ECN/PCN No.: M1738

Product Description: HIGH CAPACITANCE SUPERCAPACITORS	Abraccon Part Number / Part Series: ADCP-E02R7SA308Q	☐ Documentation only ☒ ECN ☐ EOL ☐ Series ☒ Part Number(s)
Affected Revision: Initial Revision	New Revision: A	Application: ☐ Safety ☒ Non-Safety

Mechanical Specifications

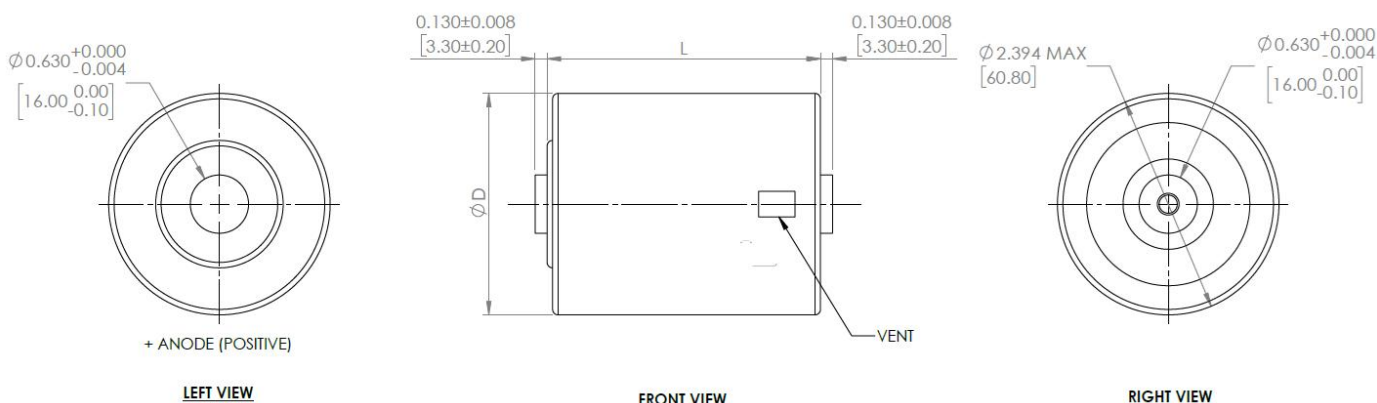
Prior to Change:

Part Number	Dimensions (ØD x L)	ØD (±1.5)	L (±0.3)
ADCP-E02R7SA128	60 x 75	60	75
ADCP-E02R7SA158	60 x 85	60	85
ADCP-E02R7SA208	60 x 105	60	105
ADCP-E02R7SA308	60 x 138	60	138

Mechanical Specifications

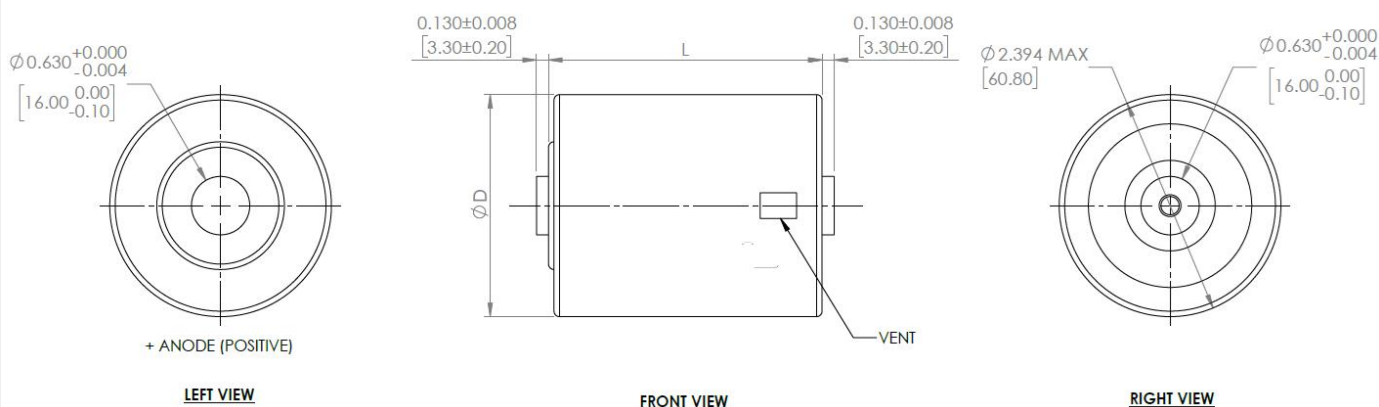
Part Number	Dimensions (ØD x L)	ØD	L
ADCP-E02R7SA128	60 x 75	60 ±1.5	75 ±0.3
ADCP-E02R7SA158	60 x 85	60 ±1.5	85 ±0.3
ADCP-E02R7SA208	60 x 105	60 ±1.5	105 ±0.3
ADCP-E02R7SA308	60.5 x 138	60.5 ±0.5	138 ±0.5

Cause/Reason for Change:

Change of production line to increase capacity.

The changes described in this document do not adversely affect the products functionality. Slight changes to mechanical dimensions may affect the product's fit.
